SHOP DRAWING REVIEW FORM AND TRANSMITTAL

RE: City of Taunton, MA
WWTF Phase 1 Improvements
Contract S-2021-1

Shop Drawing No. 16080-01 – Precast Electric Manholes, FM Structure, Frames, and Covers

SUBJECT: Precast Electrical Manholes, Frames and Covers

BASE

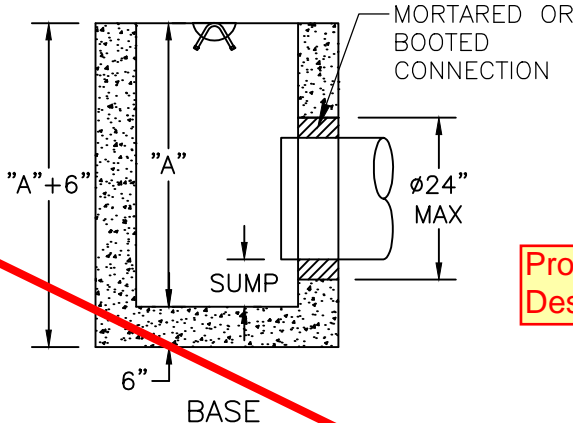
Provide w/ "Sewer" Designation

SHEA PRODUCT ID: NSM3801-2

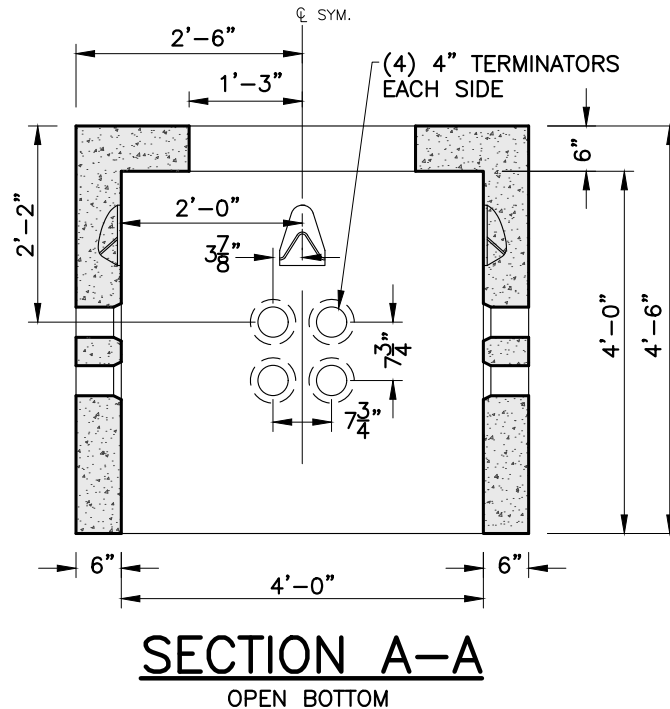
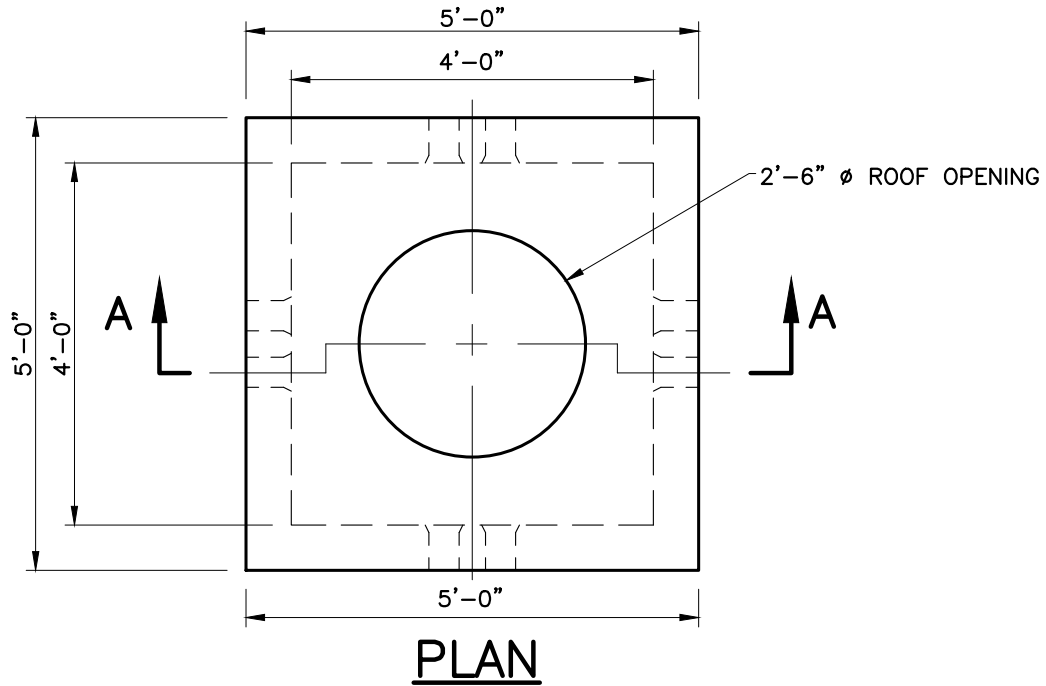
1. Coordinate the number of required conduit penetrations with the electrical contractor for both the transformer pad and handholes.
